From: Franzone, Steve [<mailto:Steve.Franzone@fpl.com>]
Sent: Sunday, October 07, 2012 5:25 PM
To: Comar, Manny
Cc: Burski, Raymond; Maher, William; Franzone, Steve
Subject: DRAFT RAI Responses FPL Turkey Point 6 & 7 for eRAIs 6006 Stability of Subsurface Materials and Foundations

NRC RAI Letter No. PTN-RAI-LTR-040

SRP Section: 02.05.04 - Stability of Subsurface Materials and Foundations

NRC RAI Number: 02.05.04-6 (eRAI 6006)

This response is PLANT SPECIFIC.

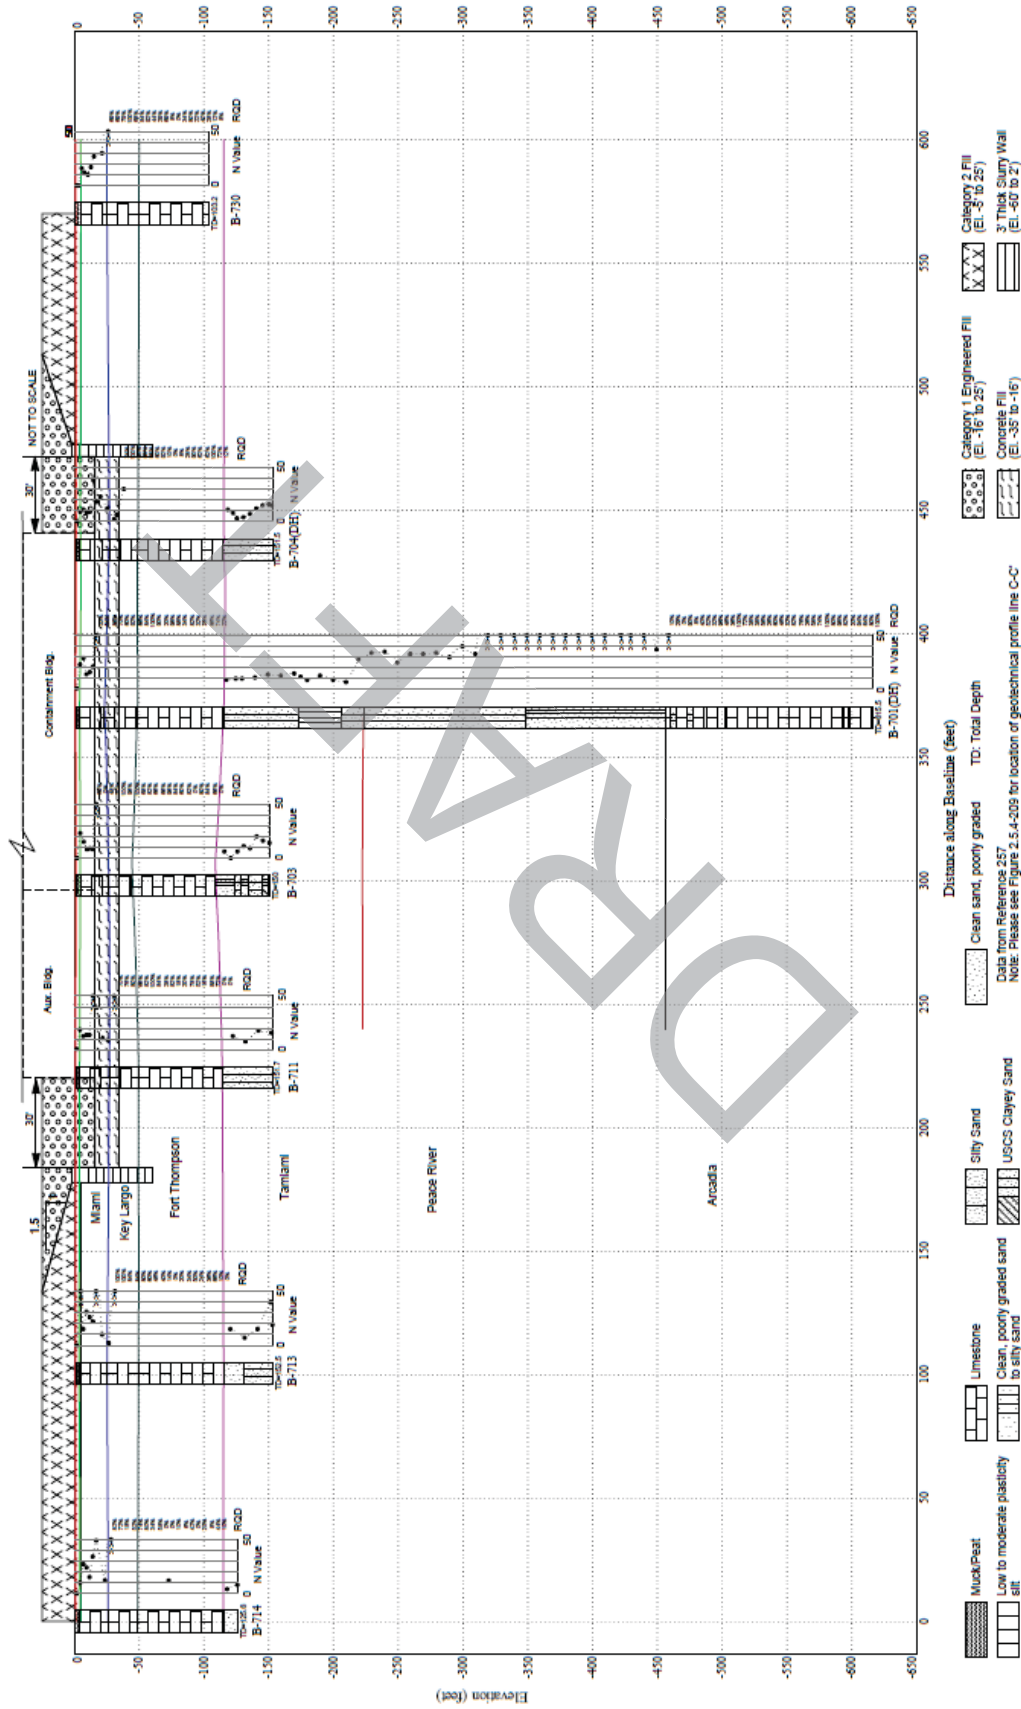
FSAR Figure 2.5.4-222 shows a general conceptual excavation cross-section. In accordance with NUREG-0800, Standard Review Plan, Chapter 2.5.4, "Stability of Subsurface Materials and Foundations," please describe the procedures that will be followed during site excavation and construction activity to ensure that the appropriate strata for the proposed foundation locations are confirmed through objective measures and the exposed foundation laying surface is uniform. Also, please provide the vertical and horizontal extent of all seismic categories I excavations, fills, and slopes, including the locations and limits of excavations, fills, and backfills on plot plans and geologic sections and profiles.

The profiles from the power block subsurface investigation (refer to FSAR Figures 2.5.4-203 through 2.5.4-208, copies of which are attached) show that the subsurface strata to support foundations are relatively horizontal. However, it should be noted that the extent of excavation to final subgrade and/or to final over-excavation level is determined during construction. This determination is based on observation and testing of actual subsurface materials encountered, and their suitability for foundation support.

Revised FSAR Figures 2.5.4-203 through 2.5.4-208 will be included in a future FSAR revision to show vertical and horizontal extent of excavations, fill locations and slopes. Note that dimensions and slopes on figures as shown are preliminary pending final design.

Figure 1. CPT Results and Derived Friction Angle for Upper Tamiami Formation

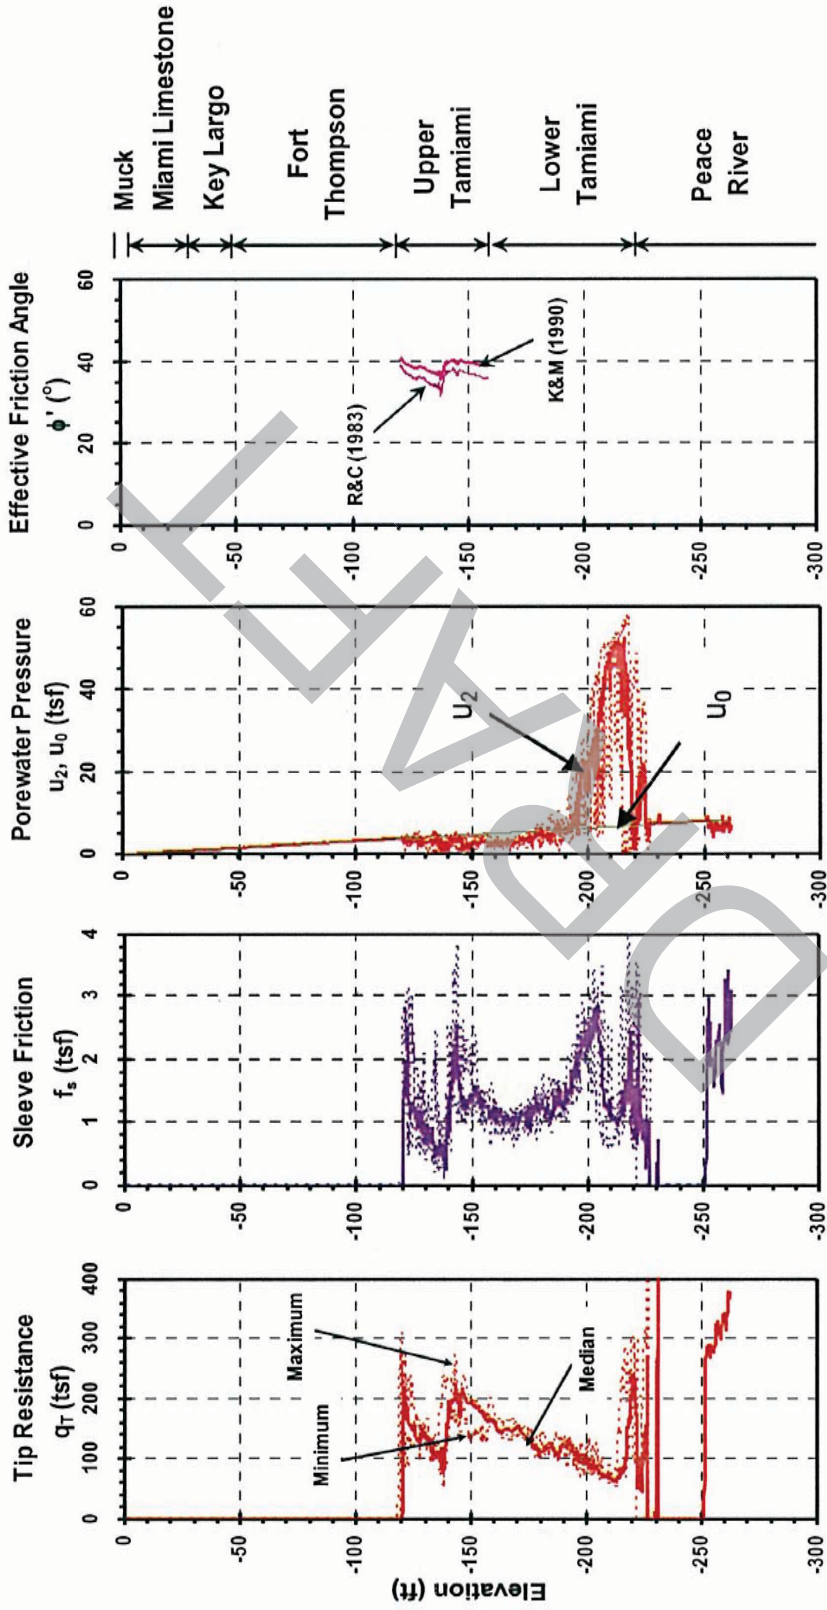
Section 2.5.4.2.1.3.8 discusses the computation of effective (drained) friction angle in each sand stratum from corrected SPT, CPT and laboratory direct shear test results. However, previous discussion in the FSAR Section 2.5.4.2.1.3.2.1 indicates that the SPT data is suspect due to anomalies of sampling, only 4 CPT profiles are available for use and no direct shear testing results were provided. Correlations of these data to generate typical soil properties are expected to have a high degree of uncertainty. Laboratory tests of these material samples can be expected to be extremely disturbed considering the depth and behavior of materials. In accordance with NUREG-0800, Standard Review Plan, Chapter 2.5.4, "Stability of Subsurface Materials and Foundations," please justify the adequacy of the friction angle. Also, provide detailed information regarding your laboratory direct-shear test program and test results.

The above correlations proposed in Reference 1 and FSAR Subsection 2.5.4 Reference 282 for cone penetration testing were used to derive the friction angles, and the results are presented in Figure 1 as a function of elevation. It is observed that the friction angles derived by these two correlations are generally in the range between 33° and 40° for the Upper Tamiami formation, which is consistent with that of 35° derived from the N_{60} -value. Thus, it is reasonable to use an effective friction angle of 35° for the Upper Tamiami formation, as listed in FSAR Table 2.5.4-209.
